# Appendix A: Responses to expert's letter dated 22nd November 2024

## Summary of responses

This PDF document shows Beca replies (in blue) to the letter prepared by Mr Lines and Dr Hargraves dated 22nd November 2024. These responses should be read in conjunction with the text in the Statement of Reply of Dan Chamberose (27 November 2024) document under Section 5. SLOPE INSTABILITY SUSCEPTIBILITY OVERLAYS AND DEBRIS RUN-OUT OVERLAY – ACCURACY OF THE OVERLAYS.

Figure A 2 - Bayview North

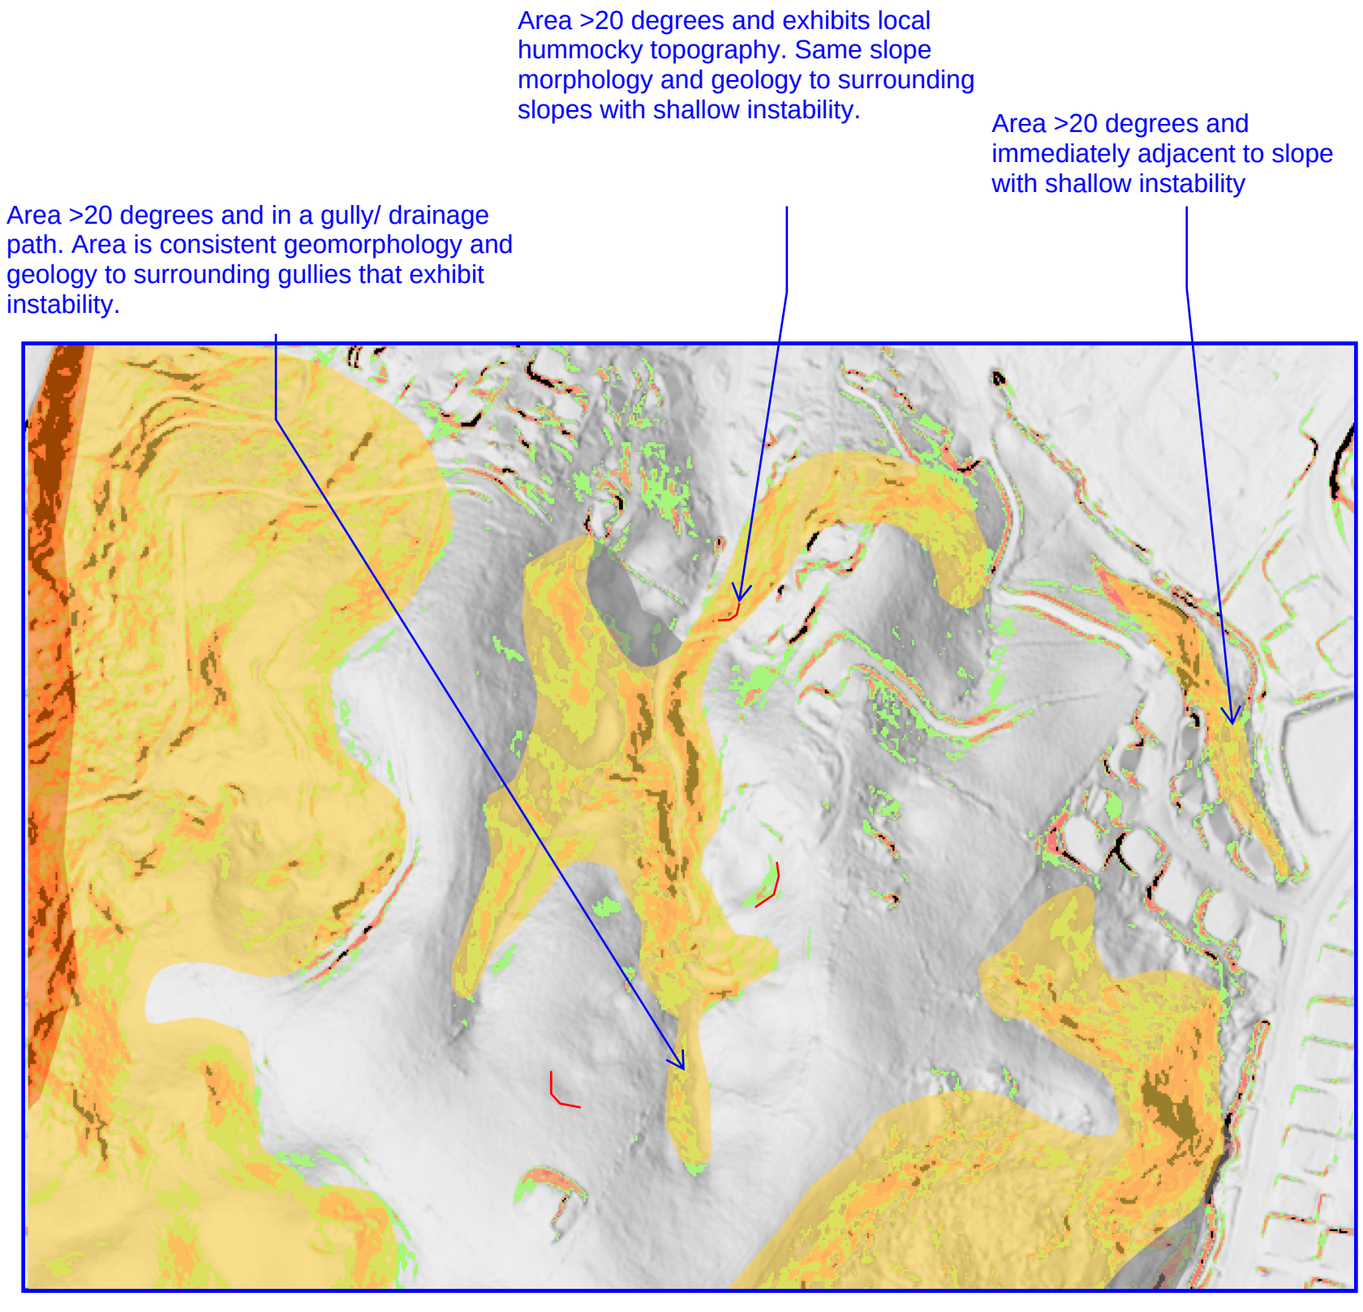
Small areas of 35° plus illustrated from automated slope angle determination from the DEM. However, Becas 2021 document allows: *"Engineering judgement has been used to determine whether slope profiles partially greater than 35 degrees have been included in the overlay. Judgement was based on the overall steepness of the slope profile using the 2 m elevation contours, overall topography, and underlying geologic units."* These areas on average well below 35°.

No - based on information provided by Beca in GIS. Which does not present any geomorphic evidence of instability.

No - based on information provided by Beca in GIS. This only adopts 1:250,000 active faults. Flaxmore fault located upslope of lots but not defined in the Slope instability susceptibility GIS.

The Beca, 2021 report explains that slopes adjacent to those with features in the slope instability inventory and exhibiting consistent geomorphic and geologic conditions to the features in the inventory have been included in the overlay. From a technical perspective, this is appropriate when identifying areas that may potentially be susceptible to slope instability, because these areas exhibit similar characteristics to where instability has occurred nearby or in the past. Furthermore, considering that the intent of these slope overlays is to act as a tool to flag where further site-specific geotechnical assessment is required and to apply planning provisions to manage slope instability risks, I believe this criterion is appropriate and reasonable to align with this intent. These areas identified in dashed red lines in A2 are included because they exhibit these similar characteristics to areas that have failed nearby; therefore, the areas should remain within the overlay and no change is required.

Figure A 3 - Bayview Central (hillshade)

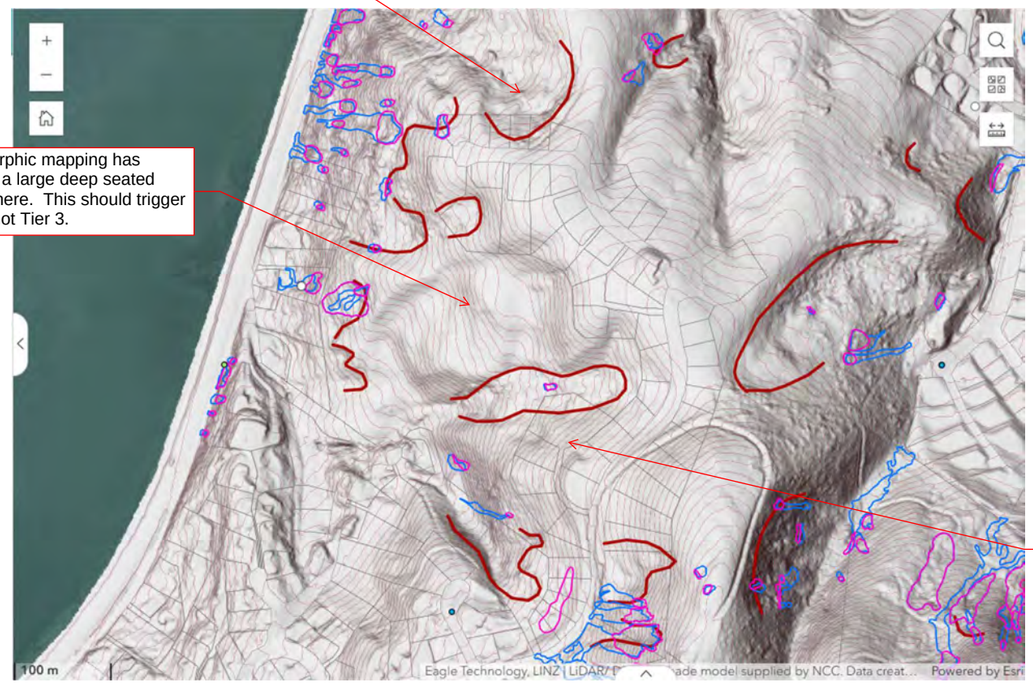
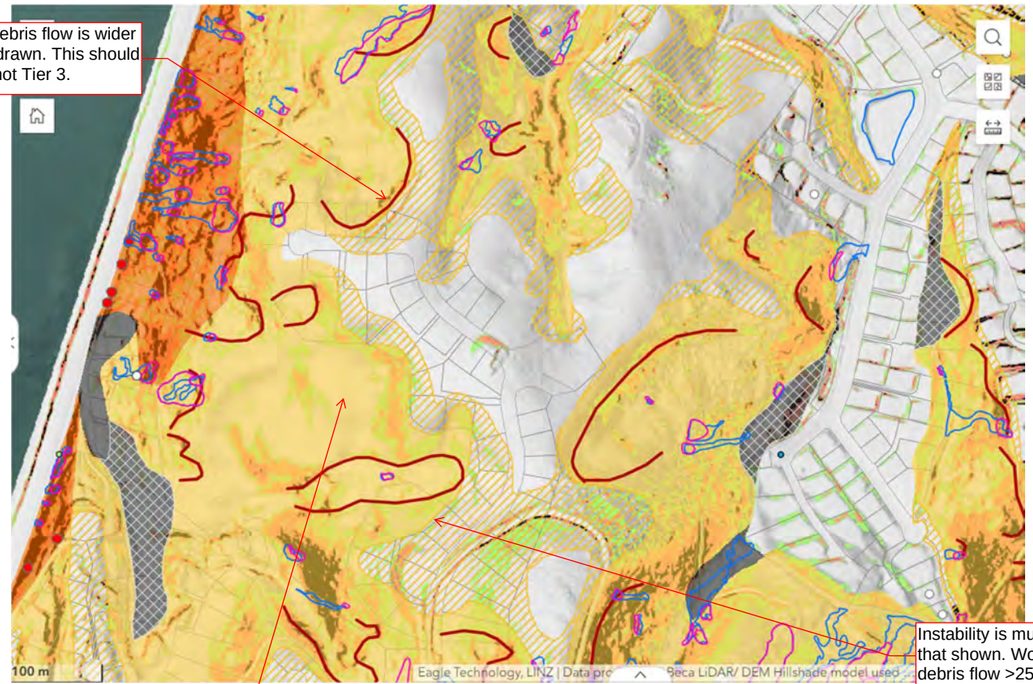
This shallow debris flow is wider than 25 m as drawn. This should trigger Tier 2 not Tier 3.

Geomorphic mapping has missed a large deep seated failure here. This should trigger Tier 2 not Tier 3.

Instability is much wider than that shown. Would classify as debris flow >25 m wide i.e Tier 2

This shallow debris flow is wider than 25 m as drawn. This should trigger Tier 2 not Tier 3.

Instability is much wider than that shown. Would classify as debris flow >25 m wide i.e Tier 2

Geomorphic mapping has missed a large deep seated failure here. This should trigger Tier 2 not Tier 3.

Based on the datasets used/available, this feature was not identified on the published geologic maps and the Beca staff did not observe a clearly defined headscarp feature in the datasets that clearly indicated a deep seated feature being present. Therefore, they did not have sufficient evidence to define it as this type of feature so it was identified as Area 3 rather than Area 2. To confirm if it was deeper seated would require field verification, intrusive investigations or site specific knowledge which was not included or available as part of developing regional scale susceptibility maps in this area. This level of detail would be expected to be provided at the site specific assessment stage that the susceptibility map would trigger.

With regards to the width of the instabilities, one instability feature identified within the mapping is identified as having a maximum width of <25m and therefore did not warrant inclusion. Other feature was interpreted as a shallow instability.

Note: The SI-TAG did not have specific comment of deep seated instability in this area and the feature identified that Beca 'missed' was not mapped in the geology map (Johnston et al. 2021). Also, if the recommendation to combine areas 2 and 3 is accepted, then the extents of the overlay will not change in this area in light of other experts comments.

Figure A 4 - Bayview Central

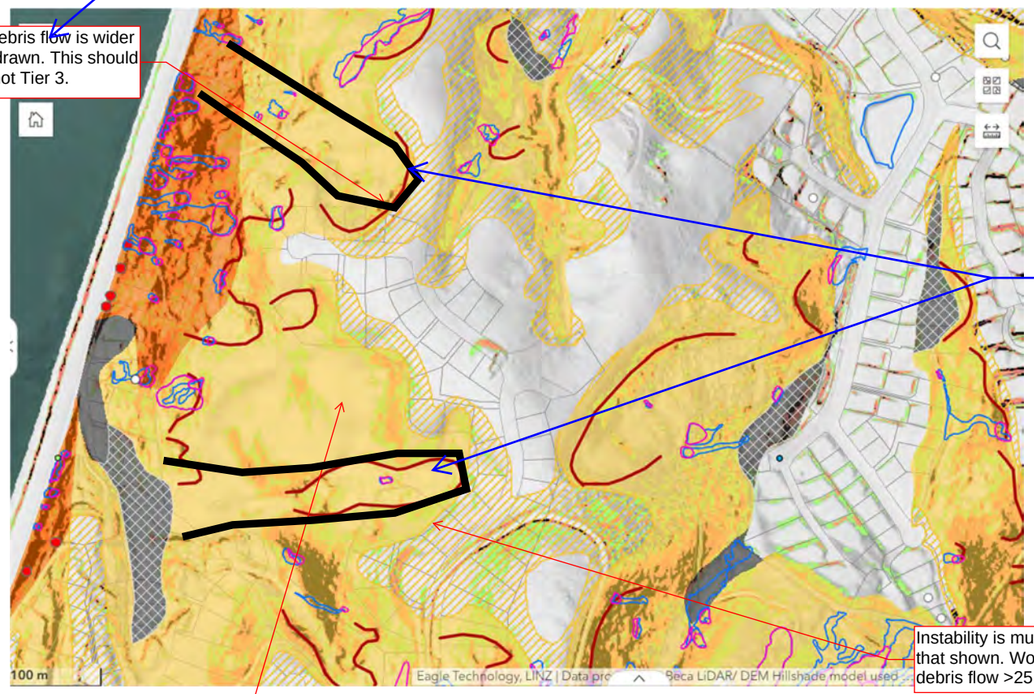
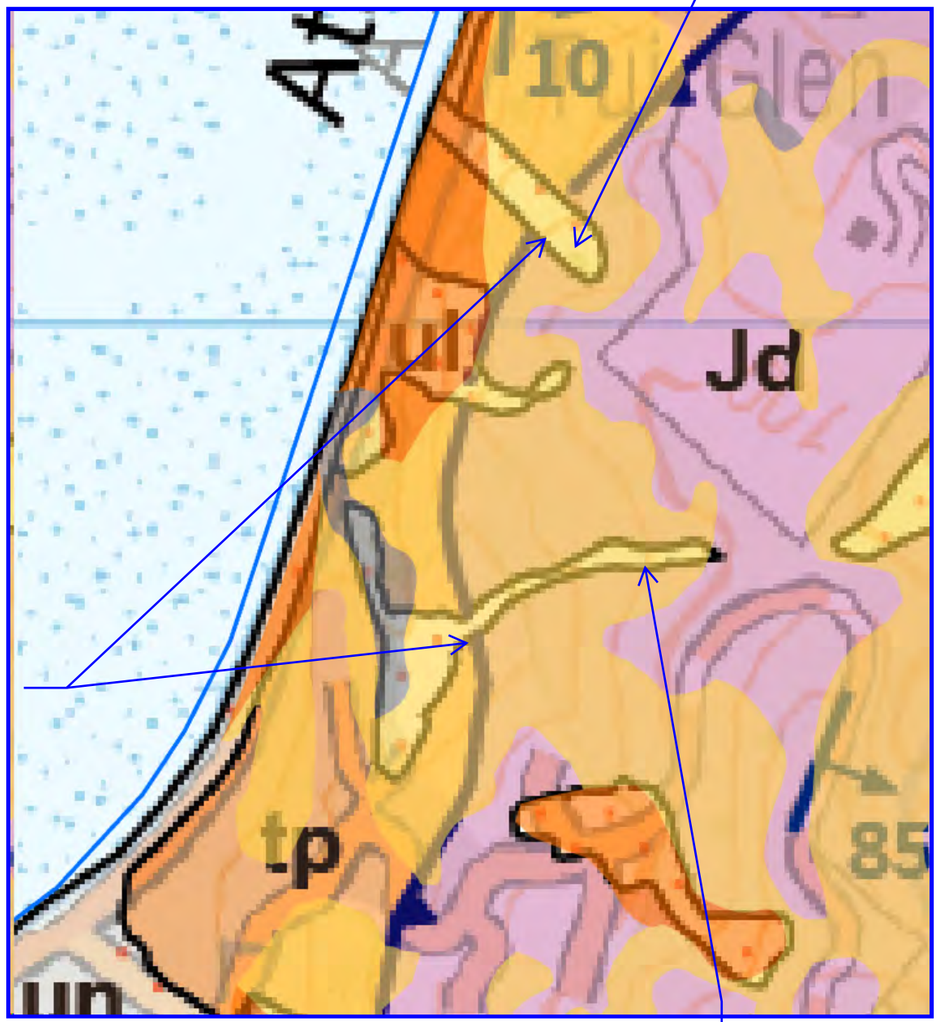
This shallow debris flow is wider than 25 m as drawn. This should trigger Tier 2 not Tier 3.

Instability is much wider than that shown. Would classify as debris flow >25 m wide i.e Tier 2

Geomorphic mapping has missed a large deep seated failure here. This should trigger Tier 2 not Tier 3.

Inconsistent terminology used by other experts. Says shallow debris flow. Earthflows were criteria for Tier II, not shallow debris flow. Interpretted as a shallow feature by Beca, therefore width does not affect this.

Features mapped in geologic map as landslide deposits

Not identified in geologic map, or a clearly defined headscarp feature observable in the datasets that clearly indicated a deep seated feature.

Widest point = >25m

Widest point =23m

Figure A 5 - Bayview Ledger

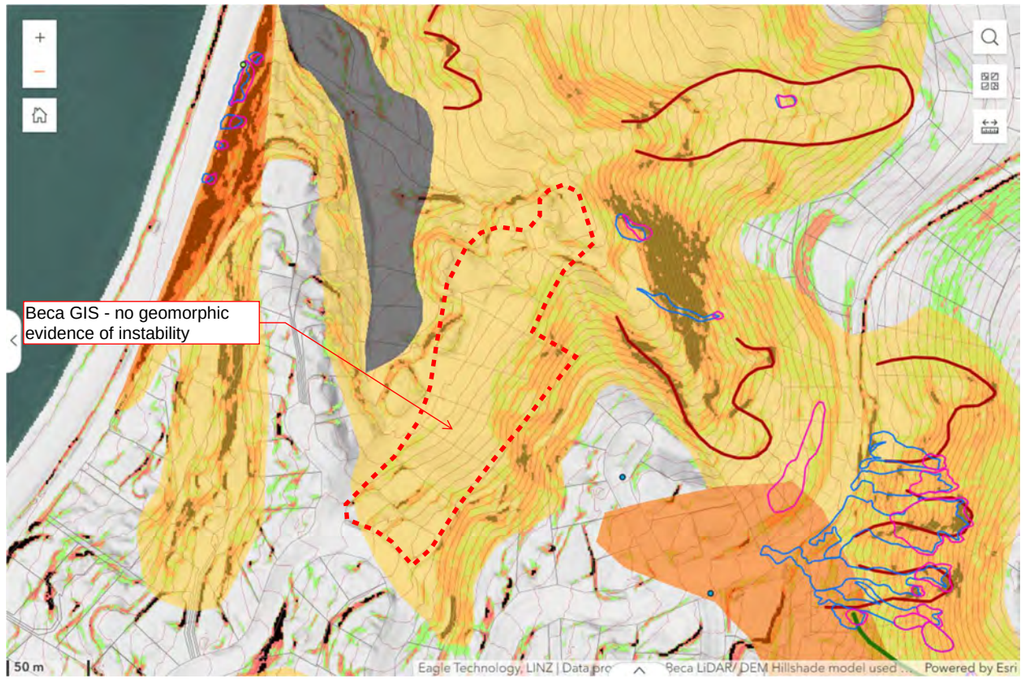
Small areas of 35° plus illustrated from automated slope angle determination from the DEM. However, Becas 2021 document allows: *"Engineering judgement has been used to determine whether slope profiles partially greater than 35 degrees have been included in the overlay. Judgement was based on the overall steepness of the slope profile using the 2 m elevation contours, overall topography, and underlying geologic units."* Ledger Road sites can clearly be considered to be on average <35°.

No - based on information provided by Beca in GIS. Which does not present any geomorphic evidence of instability.

No - based on information provided by Beca in GIS. This only adopts 1:250,000 active faults. Flaxmore fault located upslope of lots but not defined in the Slope instability susceptibility GIS.

The slope instability inventory has been created in accordance with the AGS guidance and aligns with a 'basic' level inventory. The mapping of features is not considered to be an exhaustive record of all instability in the region but is sufficient to show the classification and distribution of slope instability on hillslopes in the region. The aim of the mapping was to capture a representation of slope failure locations and types in the region. Please note that there are features interpreted in the DEM that are not included in the slope instability inventory within this area (see snip and commentary in the Statement of Reply for why features not included). These features extend into the area identified by red dashed area in A5 which is why this red dashed area is included in the overlays. Also, as described in Beca, 2021 there is evidence of slope instability on nearby slopes. The suggested change areas exhibit consistent geomorphic and geologic conditions to these areas where previous failures have occurred. Therefore, this area should remain within the overlay and no change is required.

Inferred scarps not shown in inventory that extend down into area below.

Figure A 6 - Wakapuaka Cemetery

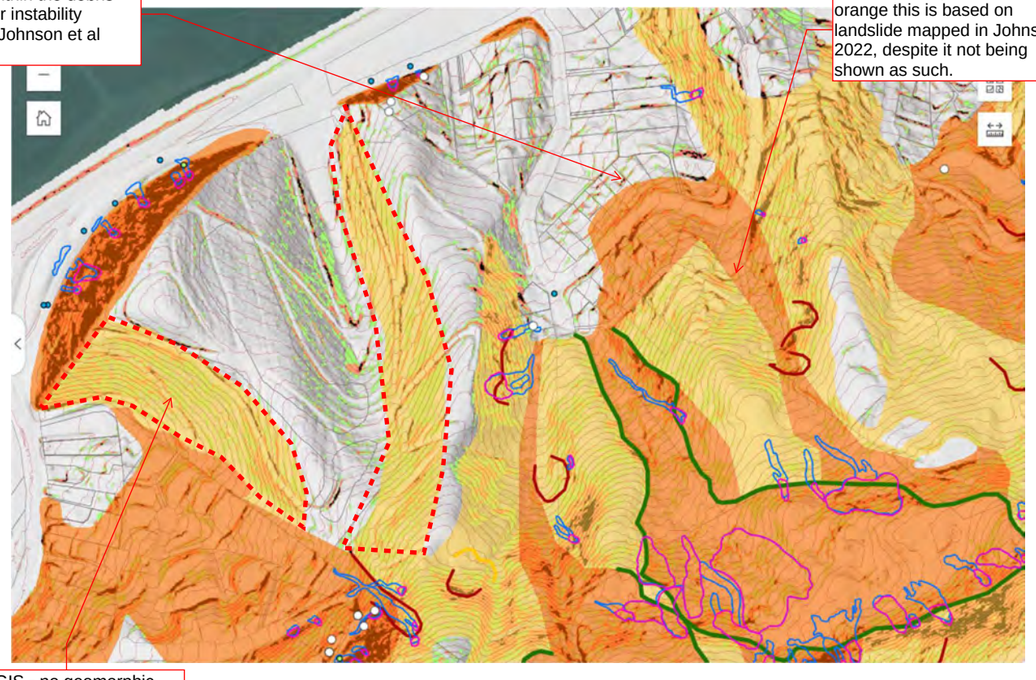
Why does Tier 2 stop, when it is still well within the debris field of major instability mapped by Johnson et al 2022?

Based on shape of Tier 2 orange this is based on landslide mapped in Johnson 2022, despite it not being shown as such.

Tier III areas identified in the Beca map are >20 degrees and exhibit consistent slope morphology and underlain by same geologic unit as adjacent slopes that have evidence of previous shallow failures including post-August features (see snips). Slope identified in A19 on the west side of the cemetery is not included within the overlay as the overall slope angle across the area is largely less than 20 degrees. Therefore the area was not included. Alternatively, the south and east slopes identified have overall slope angles of >20 degrees which is why they are included (showing consistent application of methodology). Although there is no geomorphic evidence of instability in these areas, there is in the adjacent gully in the same materials on similar slopes which is why they are included.

Note: Some of this area is outside of PC29 extents. Assuming because it is a cemetery

Slope angles taken from contours to show consistency of methodology application in terms of slope angles in this area

Note instability on adjacent hill area in the same geology and similar slope angles

Figure A 7 - Atawhai Drive, Havenview, Young Way

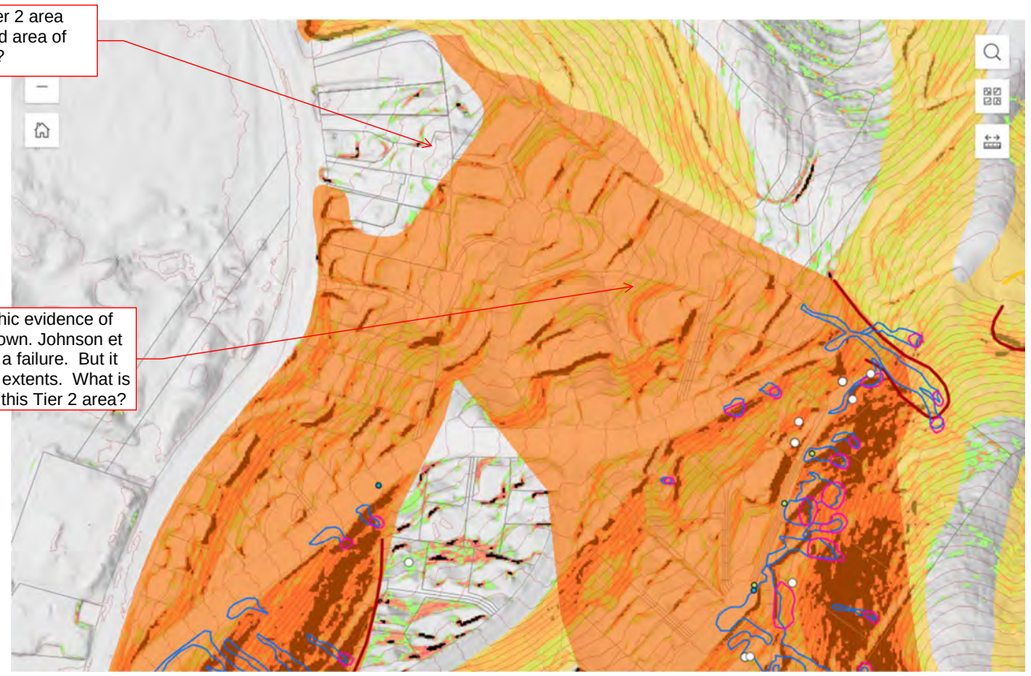
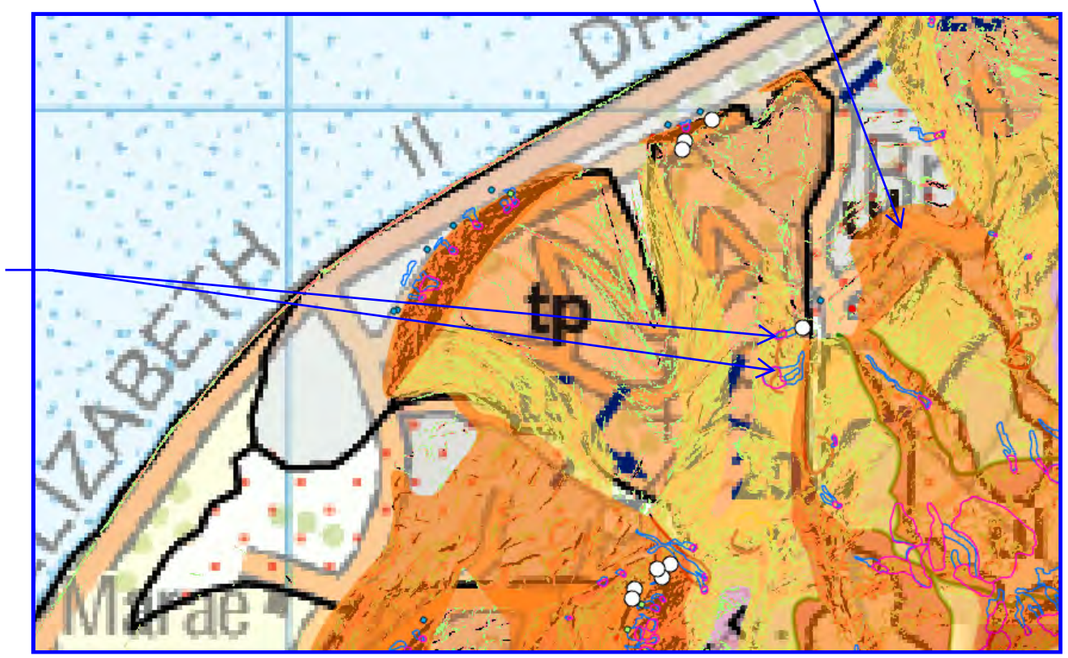
Why does the tier 2 area stop in a mapped area of landslide debris?

No geomorphic evidence of instability shown. Johnson et al 2022 map a failure. But it has different extents. What is the basis for this Tier 2 area?

Tier II area is based on the geologic map (Johnston et al. 2021) and refined/expanded to include the area upslope using the DEM as Beca were aware this area is earthflow deposits due to in-house knowledge in the area. The evidence of this earthflow has likely been obscured by the earthworks of the subdivision which is why it is not observable. It also shows the same morphology as the earthflows identified to the north east in similar gullies and geology. The toe area extent was based on initial assessment criteria considering slope angle which is why this is not included in the overlay (as described in the Statement of Reply document). No additional areas were added when this was refined into Tiers, therefore the extent reflects the initial mapping agreed with SI-TAG.

Tier II based information Beca are aware of, that includes earthflow deposits present (see adjacent map). This was included into the overlay post creation of inventory map, therefore full extent was not shown

Partially identified as landslide in geologic map, boundaries refined using topography visible in DEM. Area within eartthflow feature identified in geomorphic map which exhibits similar morphology to earthflows formed in surrounding Jd (Drumduan) unit.
